Monticello Nuclear Generating Plant  
2807 W County Road 75  
Monticello, MN 55362

Monticello Nuclear Generating Plant's Third Six-Month Status Report in Response to March 12, 2012 Commission Order Modifying Licenses with Regard to Requirements for Mitigation Strategies for Beyond-Design-Basis External Events (Order Number EA-12-049) (TAC No. MF0923)

**Monticello Nuclear Generating Plant  
Third Six-Month Status Report for Implementation of Order EA-12-049,  
Order Modifying Licenses with Regard to Requirements for  
Mitigation Strategies for Beyond-Design-Basis External Events**

**Figure 1 – RHR-RHRSW Crosstie Line (simplified)**

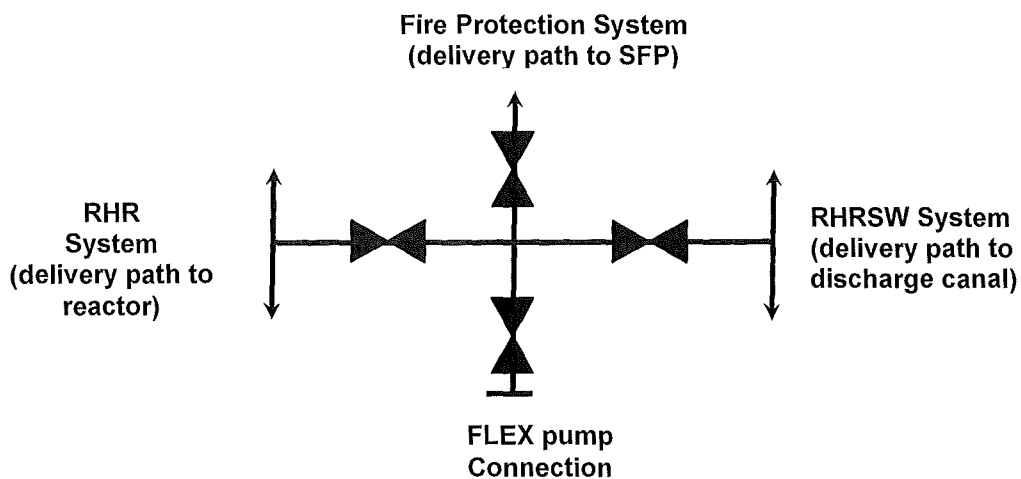
Change: The connection point for the FLEX portable pump to the RHRSW system will be in the Turbine Building versus the Reactor Building.

A FLEX portable pump connection point will be in the RHR-RHRSW crosstie located in the Turbine Building rather than in the Division I RHRSW piping located in the Reactor Building (see Figure 1). At the connection point in the Turbine Building, the operator will be able to deliver water to:

This addition will allow flow to the spent fuel pool to be controlled from the Turbine Building through fire protection piping using the FLEX portable pump connection discussed above and shown in Figure 1. The fire protection piping is not seismically designed, and therefore may not be available in all external events.
